Design change to SAF INTRA steel hanger bracket series:

In the course of continuous product improvement here at SAF-HOLLAND, we will gradually be introducing an improved hanger bracket for the INTRA series from the 4th quarter of 2016. The new design has several advantages with regard to vehicle implementation and the alignment of the hanger brackets on the vehicle frame.

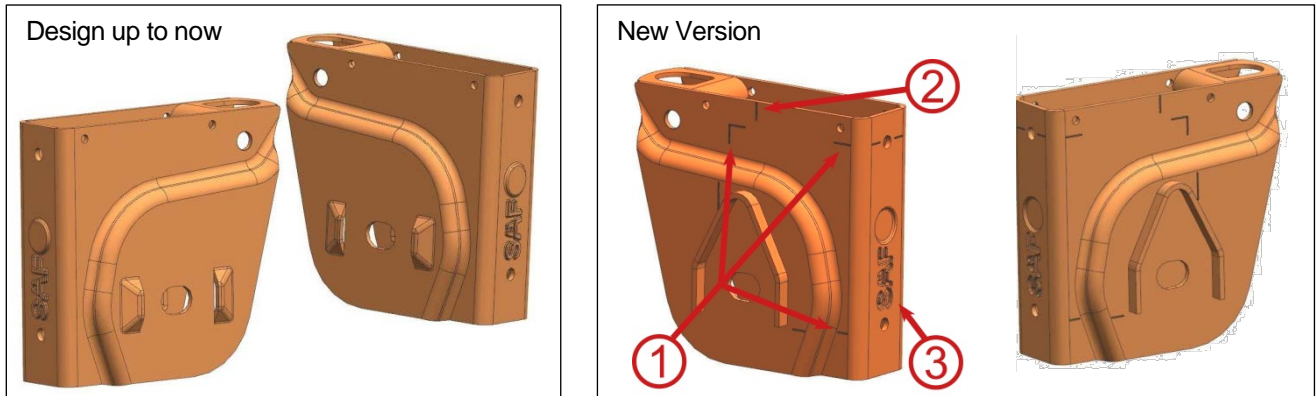
- **New:** 1) Marked area showing where to mount the cross member.
- **New:** 2) Marking of pivot bolt makes positioning easier.
- **New:** 3) Mounting of cross member is made easier by engraved SAF lettering

- Existing paintwork masking can continue to be used.
- Only homogeneous products can be mounted on the vehicle.
- The tightening torques of the spring bearings remain unchanged.
- Please note that there may be an effect on the integration of your cross members (We provide the relevant information).
